Resolution No.: 360

A RESOLUTION TO AMEND THE TALBOT COUNTY COMPREHENSIVE WATER AND SEWER PLAN FOR THE PURPOSES OF APPROVING AN ALTERNATE LOCATION FOR THE PUMP STATION AND EXPANDING THE POTENTIAL ROUTE FOR THE FORCE MAIN TO PROVIDE SANITARY SEWER SERVICE TO THE UNIVERSITY OF MARYLAND MEDICAL CENTER SHORE REGIONAL MEDICAL CENTER, TO BE LOCATED AT 10000 LONGWOODS ROAD, EASTON, MARYLAND, AND THE TALBOT COUNTY COMMUNITY CENTER, LOCATED AT 10028 OCEAN GATEWAY, EASTON, MARYLAND, AS INITIALLY SET FORTH IN RESOLUTION NO. 184, ADOPTED ON SEPTEMBER 13, 2011

**AMENDMENT TO CHAPTER TWO OF THE TALBOT COUNTY COMPREHENSIVE
WATER AND SEWER PLAN**

Exhibit B-1

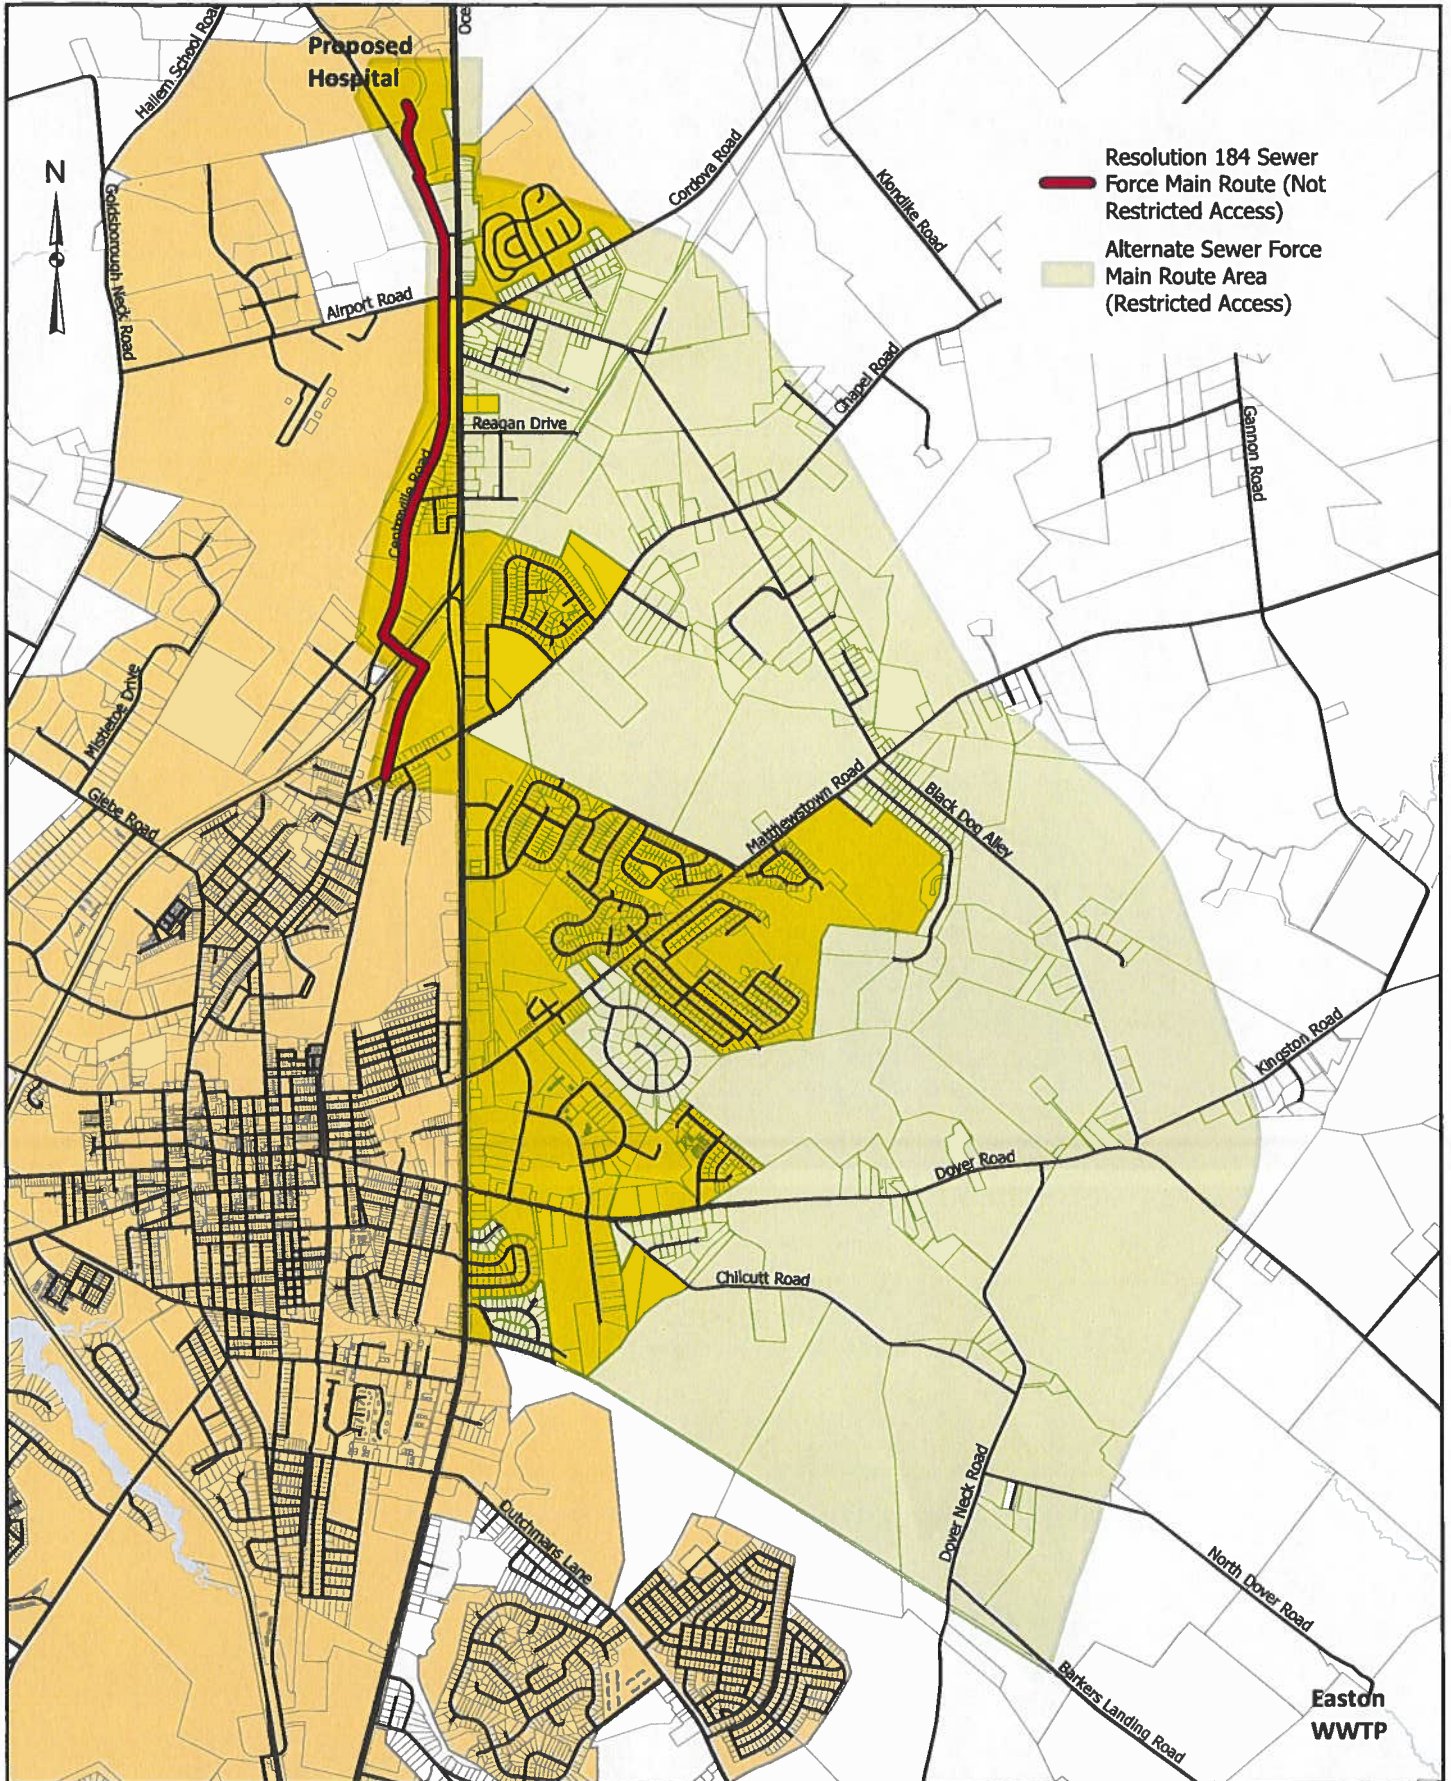
The Easton sewerage service expansion will consist of 8- ~~thru~~ through 12-inch diameter gravity sewer mains, a 225,000 gpd wastewater pumping station, and ~~a 12” diameter~~ an appropriately sized force main as indicated on the attached SHS Sewer Extension Map exhibit or, alternatively, as shown in Exhibit S-1. The ~~12” diameter~~ force main will either: 1) follow along Longwoods Road, cross U.S. Route 50 at Black Dog Alley, continue south along the Black Dog Alley corridor, and tie in to the collector force main at Dover Neck Road and Barkers Landing Road; 2) follow the proposed realigned Longwoods Road south to an existing Town utility easement extending between ~~Rts.~~ Routes 662 and 322, then cross ~~Rt.~~ Route 322, and run through another Town utility easement located south of the Suburban Propane facility. ~~From this easement, the forcemain will~~

and then run along the boundary of the athletic fields near the Rails to Trails easement to the connection point with the existing system at Chapel Road; or 3) follow along a route within the shaded area designated as “Alternate Sewer Force Main Route Area (Restricted Access) on Exhibit B-1 and determined the most appropriate from economic, engineering, and rights-of-way acquisition perspectives and as approved by Easton Utilities. Regardless of the route chosen, the force main shall not serve any properties, lots, or parcels other than the UMMS/SHS campus and the Talbot County Community Center and any such properties, lots, or parcels already eligible for sewer service from the Town under the CWSP. No other properties, lots, or parcels shall be entitled to sewer service via the force main absent an amendment to the CWSP. The design flows required for the planned medical campus’s and Community Center’s initial and proposed sewer demands are 81,750 and 225,000 gpd, respectively.
